Wollongong Local Planning Panel Assessment Report | 13 February 2018

WLPP No.	Item No. 1
DA No.	DA-2018/1192
Proposal	Residential - demolition of existing structures, tree removals and construction of multi dwelling housing - five (5) townhouses.
Property	28 George Street, THIRROUL NSW 2515 Lot 28 DP 1099628
Applicant	Mr Marko Lisica
Responsible Team	Development Assessment and Certification – City Wide Planning Team (MB)

ASSESSMENT REPORT AND RECOMMENDATION

Figure 3: Trees identified in Arborist Report (Prepared by Mark Spence dated November 2018)

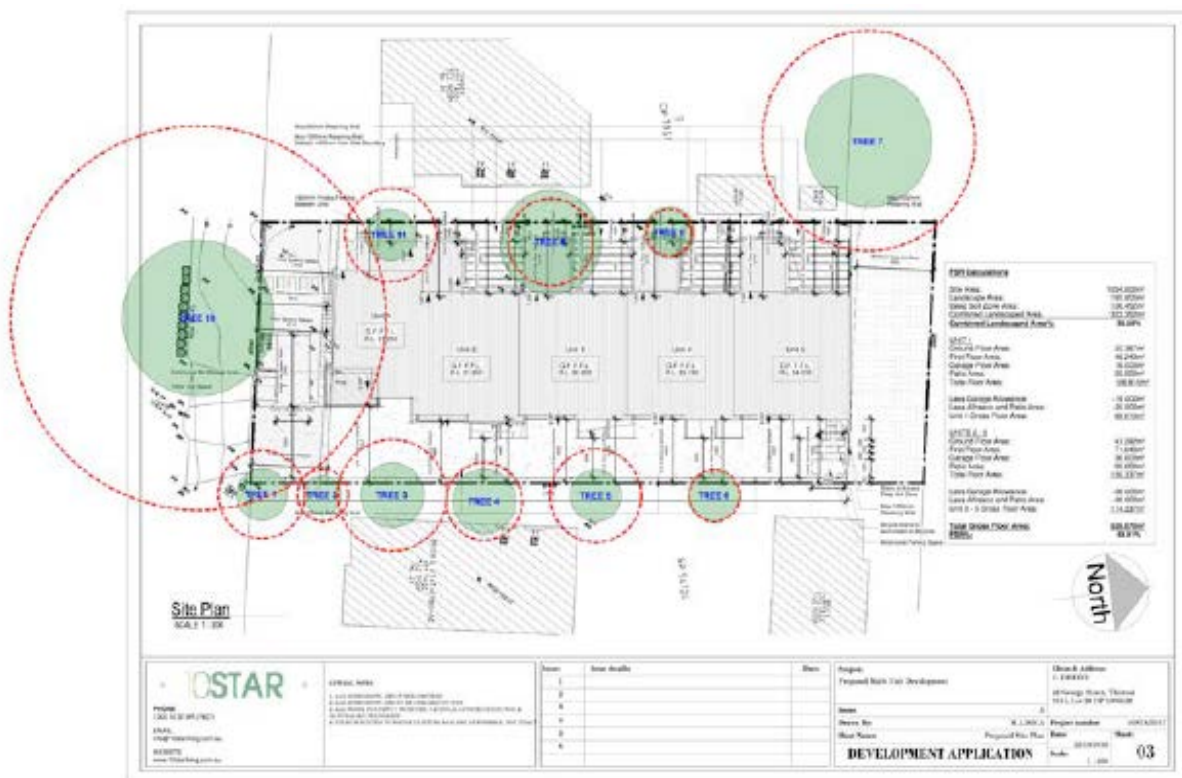
A total of eleven trees were inspected at 28 George Street. One of these trees is a street tree and seven others are located on neighbouring properties.

Council's Landscape Officer has reviewed the application submission. Conditionally satisfactory referral advice was received, and conditions specify trees to be removed, trees to be retained, tree protection and management and compensatory plantings.

- 4 **Tree Management**
The developer shall retain existing trees indicated on Concept Landscape Plan by Mark Spence Drafting Dwg. No. MS2018194 Issue B dated 5 January 2018 consisting of tree numbered 1, 2, 3, 4, 5, 6, 7 and 10 on adjacent properties. Total number: eight (8 No.).

The developer shall transplant tree numbered 8 and 11 (Total number: two (2 No.)) to an appropriate location on site by an experienced and qualified contractor.

The developer shall remove existing tree number 9. Total number: one (1 No.) No other trees shall be removed without prior written approval of Council.

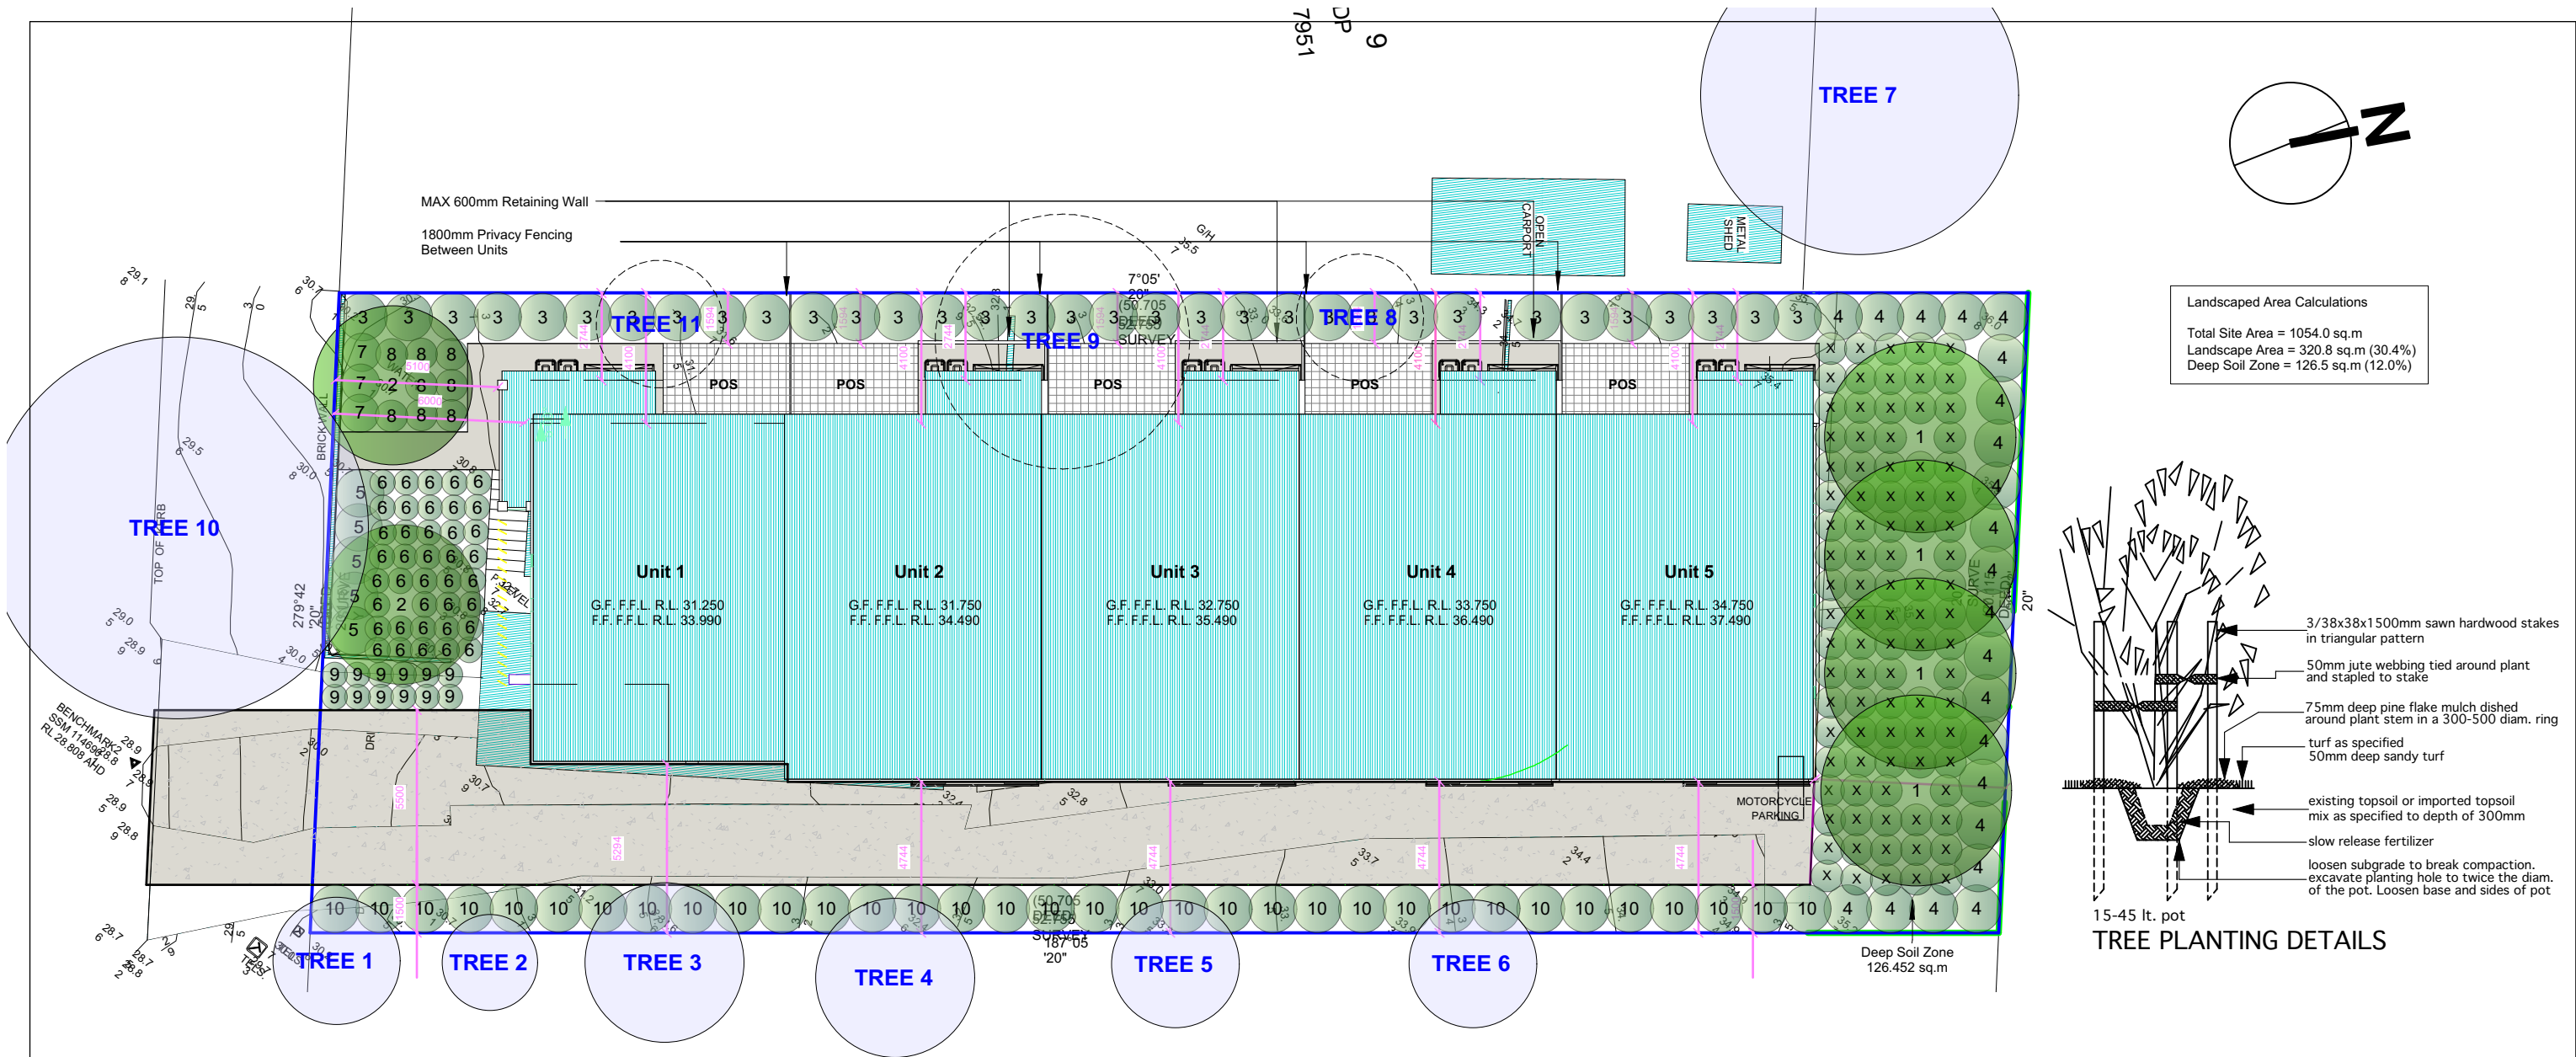
- f deletion of the following plant species since they are unsuitable for this type of development *Tristania laurina* 'Luscious' Suggested species *Waterhousea floribunda* 'Sweeper'; and;

The submission of a final Landscape Plan to the Principal Certifying Authority, prior to the release of the Construction Certificate. The final Landscape Plan shall address the following requirements:

Image above shows amount of encroachment diagonally hatched.

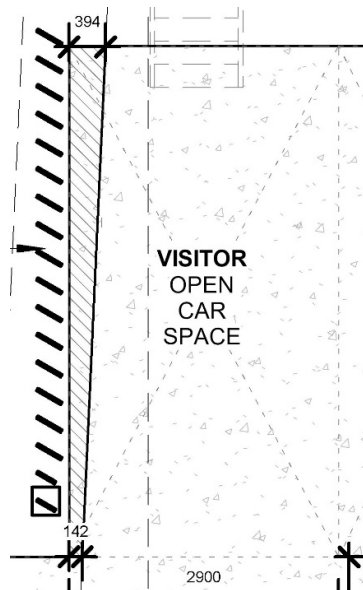
The proposed development seeks a variation to the above DCP clause 5.7.2.1. the visitor spot slightly encroaches into the front setback by a max of 394mm. Please refer to the image below for more information.

In conclusion, the above variation is slightly varying from the code 5.7.2.1. as set out by Wollongong City Council Development Control Plan. The visitor car space only slightly encroaches over the front building line by a MAX of 394mm and is screened by privacy slats. The proposed variation has no negative impact to the occupants, neighbouring dwellings, streetscape, access, transport methods or manoeuvrability on site therefore is permissible from a planning perspective.

A DCP variation for a 394mm encroachment into the front setback for visitor parking has been sought, which can be supported in this instance as outlined in the body of the report.
